GOVERNIENT OF INDIA MINISTRY OF RAILWAYS RESEARCH DESIGNS & STANDARDS ORGALISATION

No. EL/3.2.172

Modification Sheet No.WAG5/24

- 1. <u>Title</u>: Adoption of modified commutator and bearing bracket on traction motor type HS 152501.
- 2. Application: Traction motor type HS 15250A.
- 3. Object: Railways have reported that during maintenance shed people are facing lot of difficulties in attending the brush holders in assembled traction motor type HS15250A. This problem has been studied in detail. The main reason for this is the non-availability of inspection window in the commutator end bearing bracket.

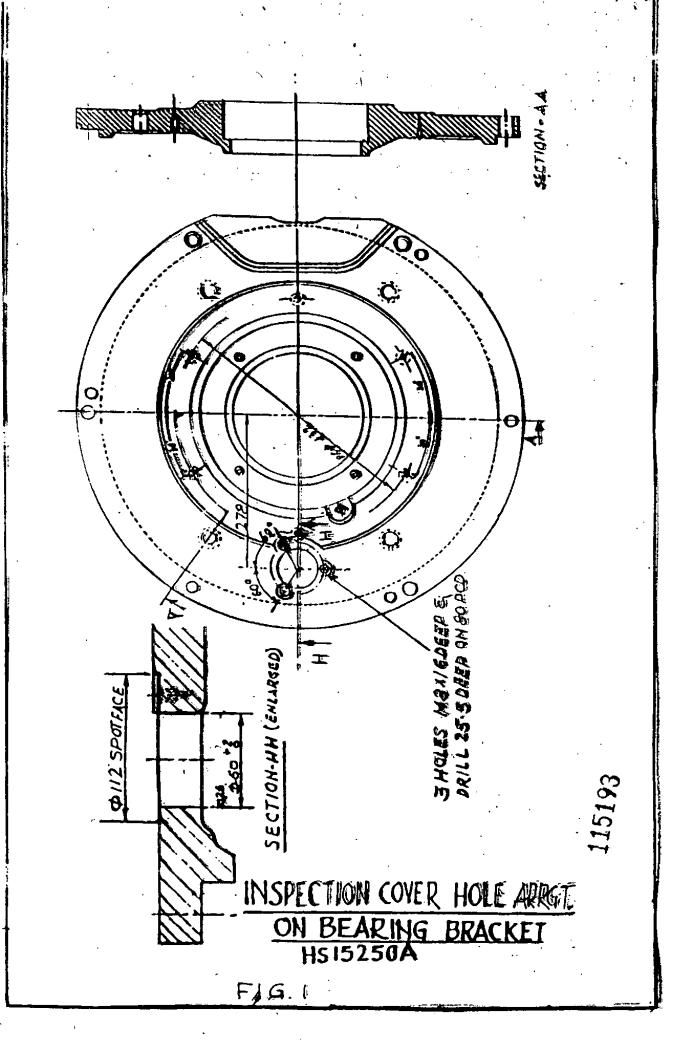
In the original design of Hitachi Traction Motor, there is no provision of inspection window in the commutator end bearing bracket.

The matter has been discussed with CLW and BHEL in detail and it was recommended to have an inspection window in CE bearing bracket in line with TAO 659 Traction Motor. M/s BHEL and CLW have agreed. M/s BHEL has already implemented this modification on their traction motor from S1. No. 4672399 onwards.

- 4. Work to be carried out :
- 4.1 Refer the attached Fig. . No. 1 & 2(cony enclosed)
- 4.2 CE bearing bracket to be modified as shown in 'HH' of the Fig. No. 1.
- 4.3 Cover to be made as per attached Fig. . No. 2.
- 4.4 Before putting back motor into service ensure that hole is covered with the inspection cover.
- 5. Schedule of Implementation:
 - For Zonal Railways : During overhaul/repair.
 - Production Units : On their regular production.
